Beaver Valley Power Station, Unit No. 1
Proposed Technical Specification Change No. 208

Beaver Valley Power Station, Unit No. 2
Proposed Technical Specification Change No. 74

Beaver Valley Power Station, Unit Nos. 1 and 2 Proposed Technical Specification Change No. 208 and 74 REVISION OF SPECIFICATIONS 2.1.1, 2.2.1, AND 3.2.5

FIGURE 2.1-1

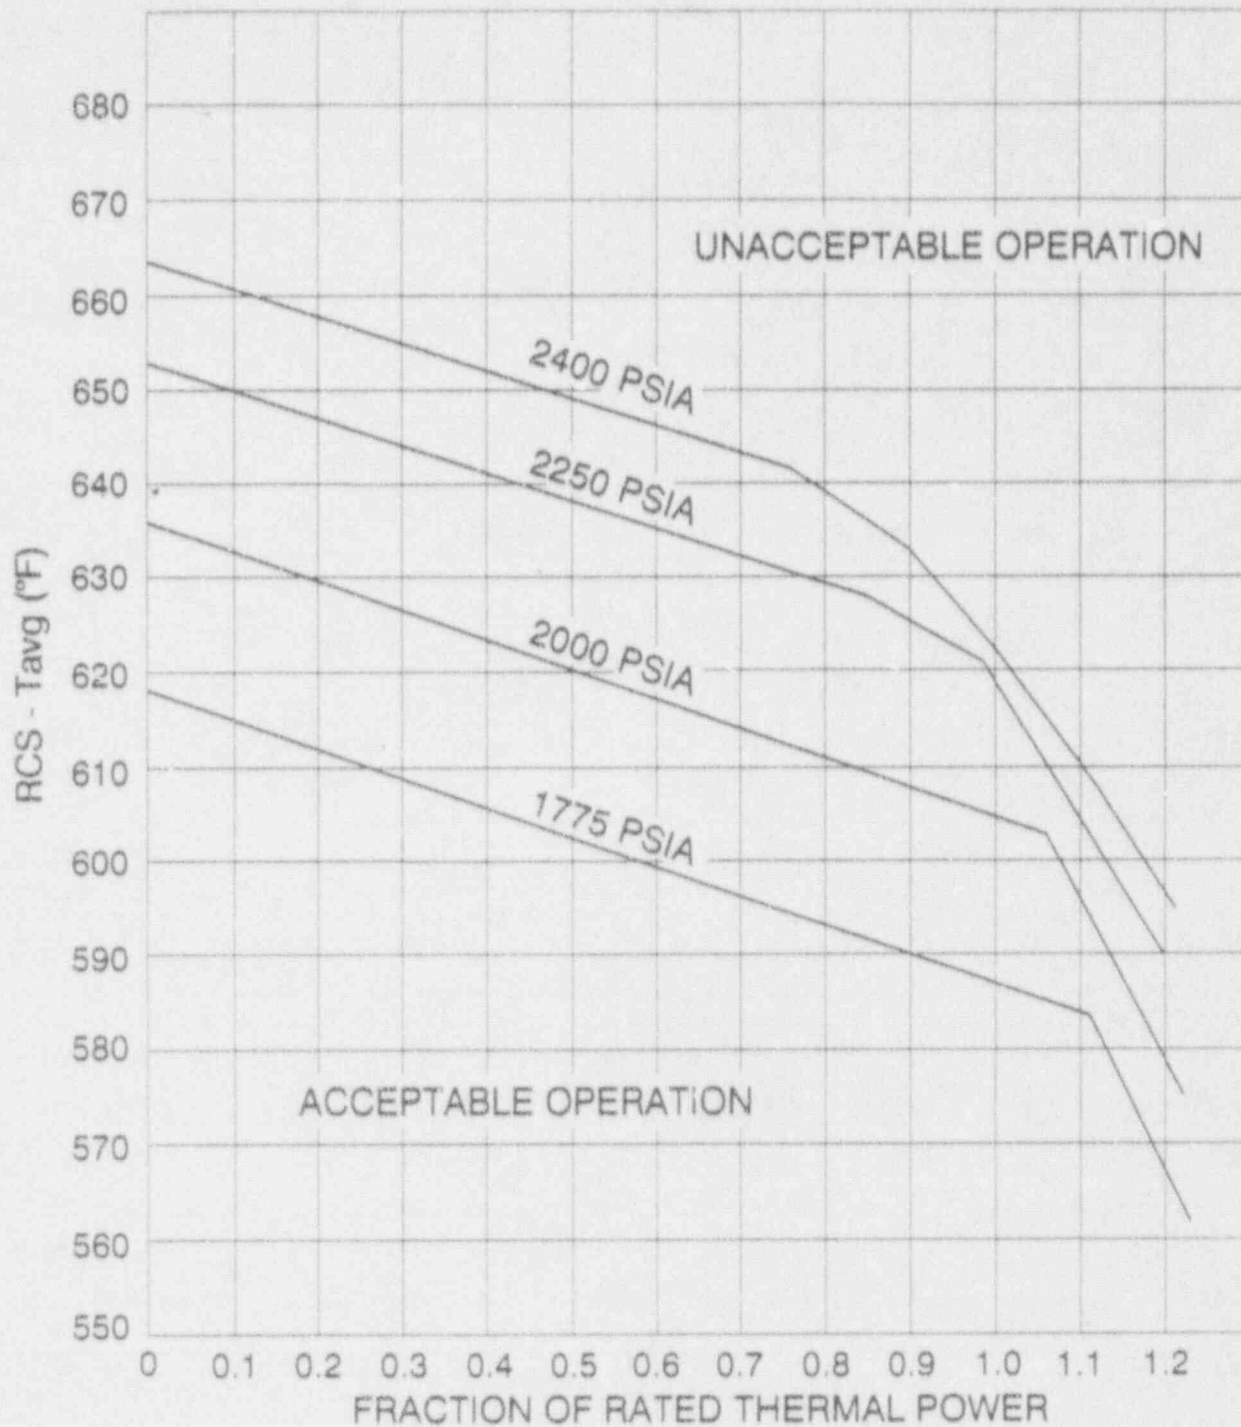
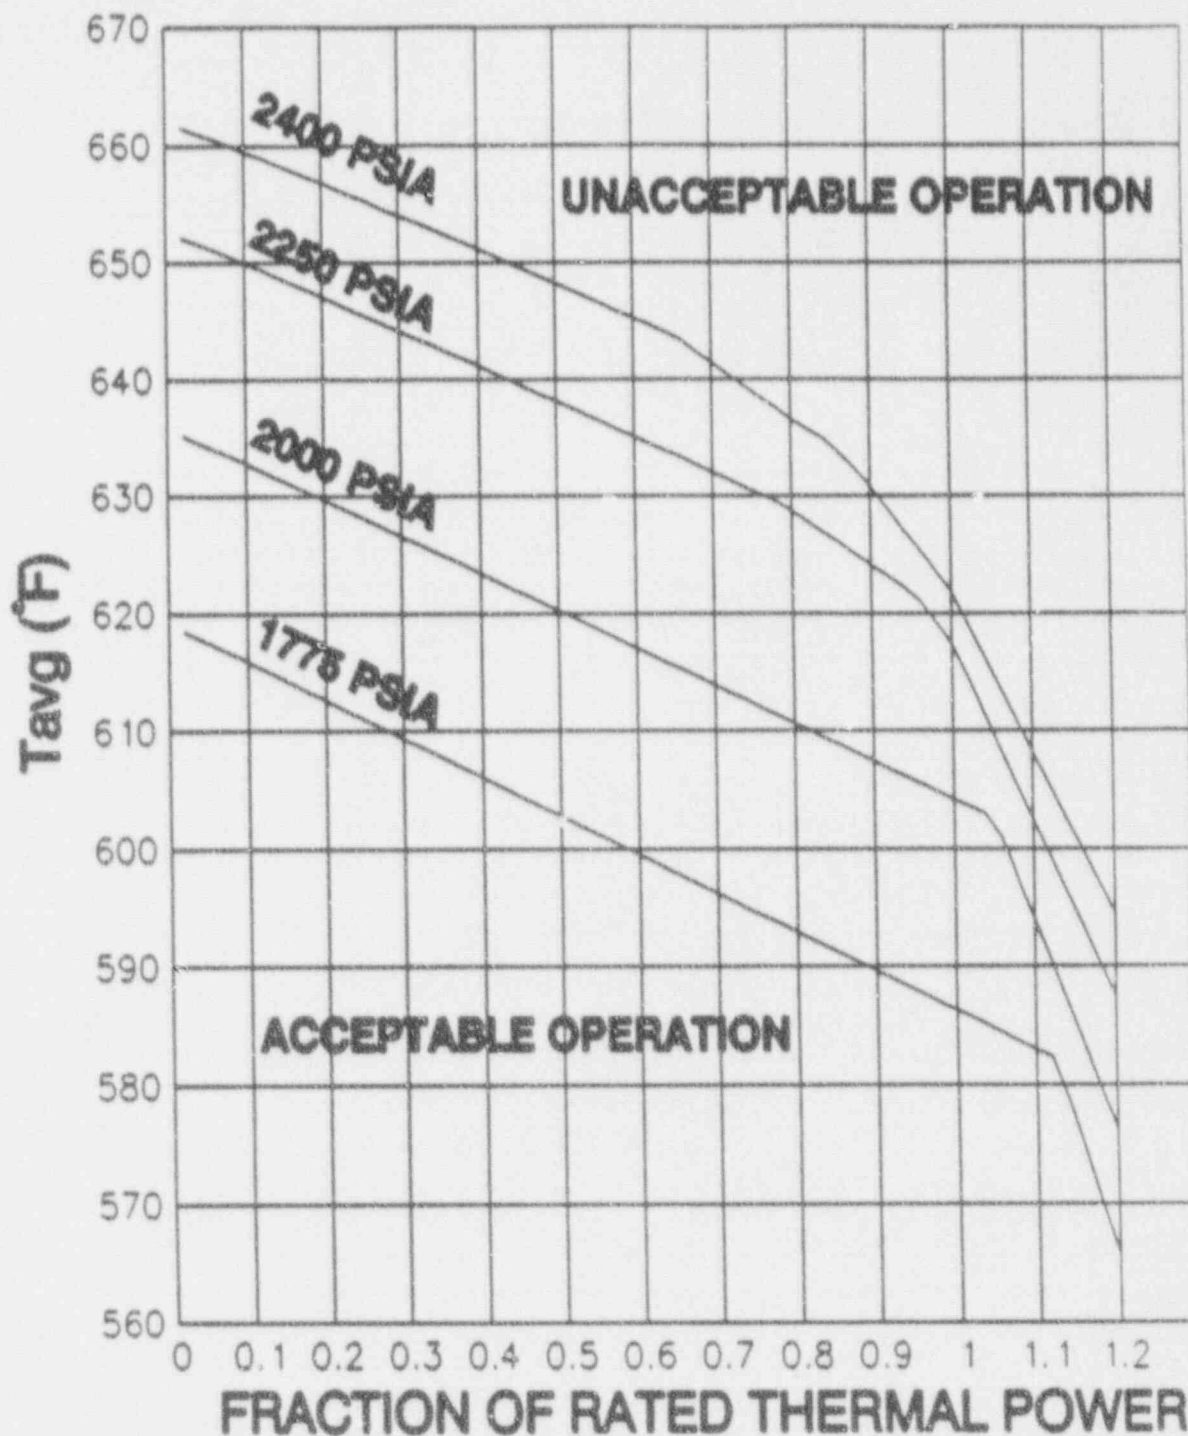
REPLACE WITH
INSERT "A"

For BVPS Unit No. 1, Figure 2.1-1 would be revised to support the 1.5 percent reduction in required RCS total flow. Table 2.2-1 would be revised by changing the value for design flow per loop from 88,500 gpm to 87,200 gpm. Also, the allowable value for table item 12 titled "Loss of Flow" would be changed from 88.9 percent to 89.0 percent. Limiting Condition for Operation (LCO) 3.2.5 would be revised by adding a footnote, designated by the number one, pertaining to Table 3.2-1. The footnote would state that the values contained in Table 3.2-1 correspond to analytical limits used in the safety analyses. The Applicability for LCO 3.2.5 would also be revised by adding a footnote designated by the number two. This footnote would state that the provisions of Specification 4.0.4 are not applicable for RCS total flow rate. Table 3.2-1 would be revised by changing the value of RCS Tavg from 581°F to 580.7°F. The value for RCS total flow rate would also be changed from a 265,500 gpm to 261,600 gpm. The existing footnote on Table 3.2-1 would be designated by the number one instead of a single asterisk. The references to two loop operation would also be removed from Specification 2.2-1 and Table 3.2-1. Figures 2.1-2 and 2.1-3, which also pertain to two loop operation, would be deleted. The Bases section for Specification 2.2-1 and the Figure Index would be revised to reflect the deletion of Figures 2.1-2 and 2.1-3.

The proposed changes to Figure 2.1-1 will be more restrictive by reducing the acceptable operation range for a given Tavg and fraction of rated thermal power. This reduction in the acceptable operation range is necessary in order to ensure analysis limits are met with a reduced TDF.

FIGURE 2.1-2
REACTOR CORE SAFETY LIMIT
TWO LOOPS IN OPERATION (ONE LOOP ISOLATED)

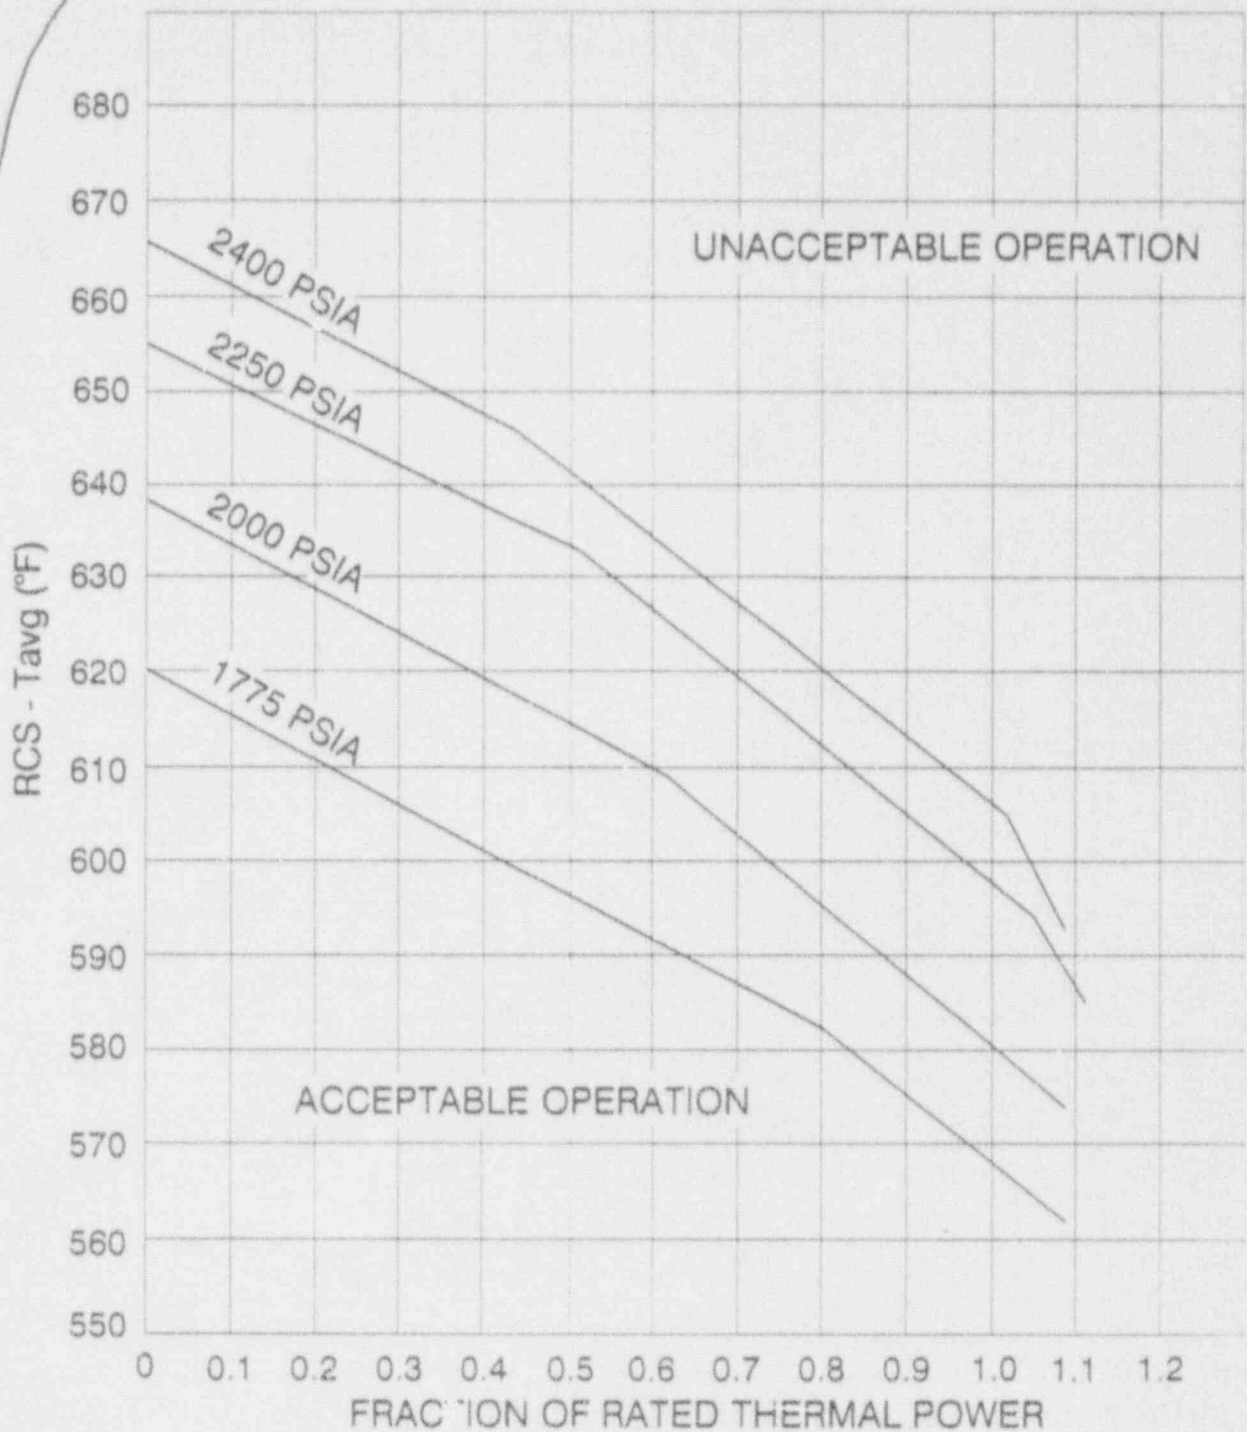
← DELETE

The deletion of Figures 2.1-2 and 2.1-3 (for Unit No. 1 only) and their references in the Figure Index, Specifications 2.1.1 and associated Bases is administrative in nature. These two figures are no longer required. Plant operation with less than three RCS loops is not permitted by our current license. Also, the current safety analyses do not take into account two loop operation. Therefore, technical specification Figures 2.1-2 and 2.1-3 can be deleted since they are no longer applicable for Unit No. 1 operation.

FIGURE 2.1-3

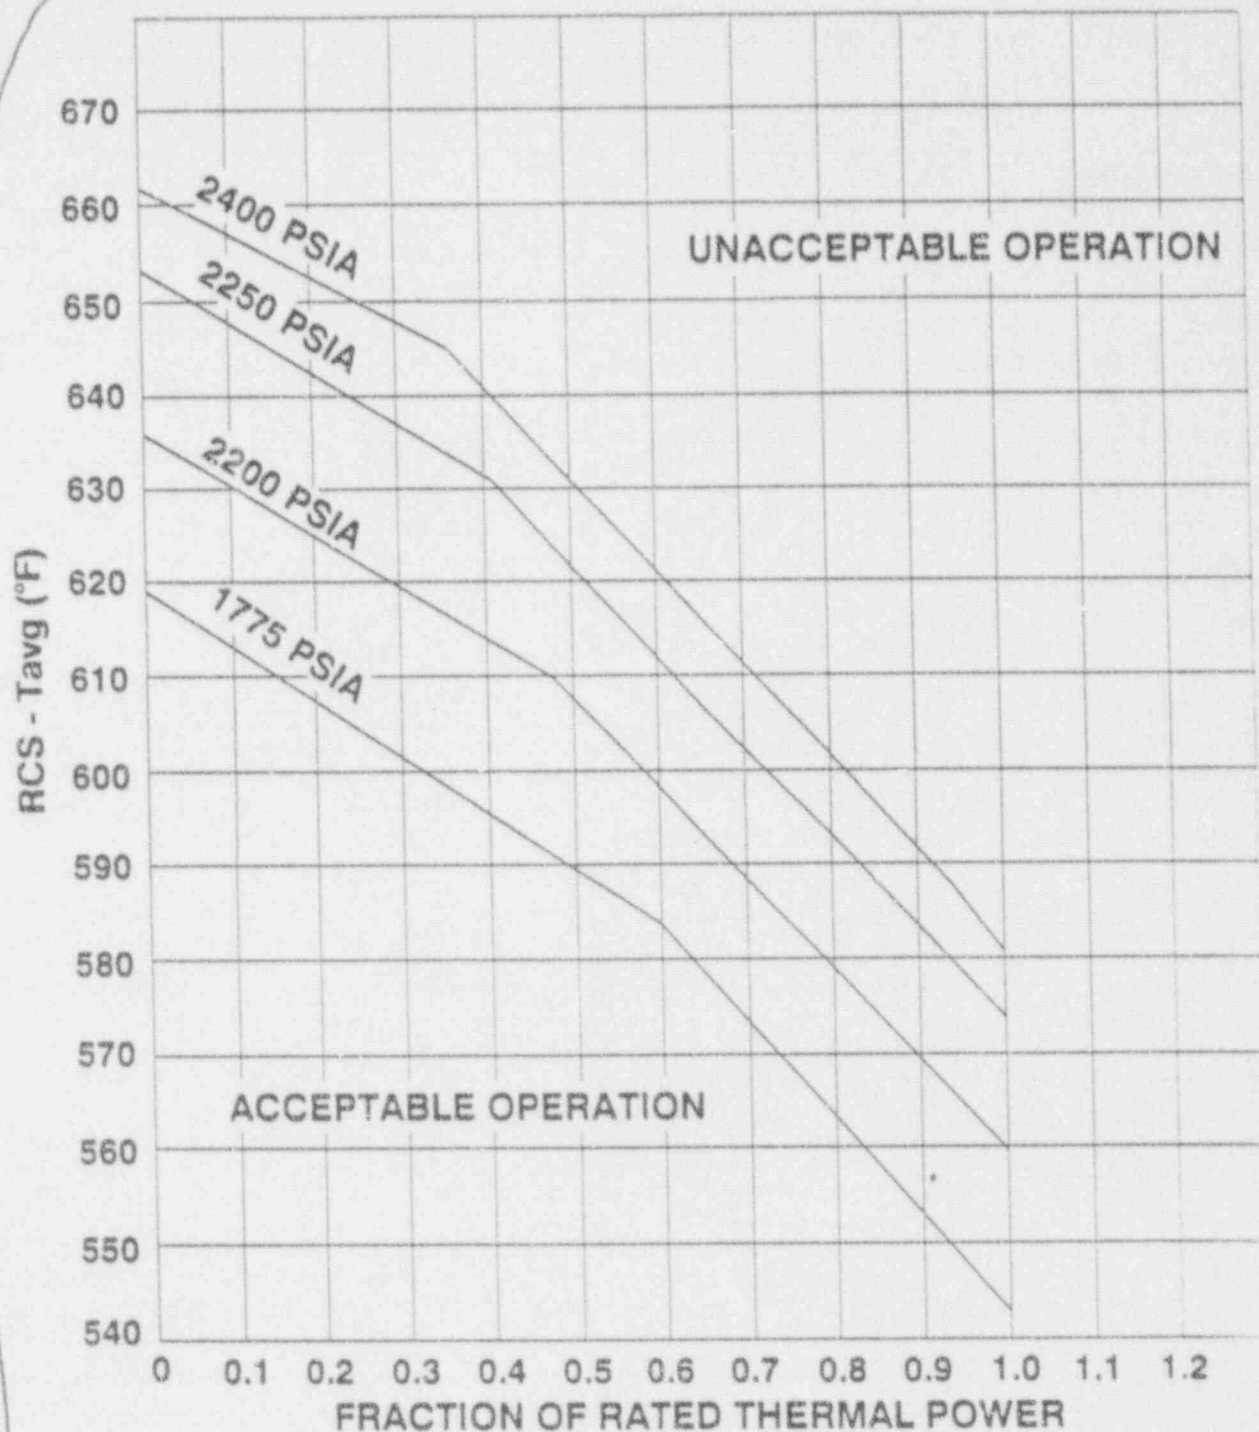
DELETE
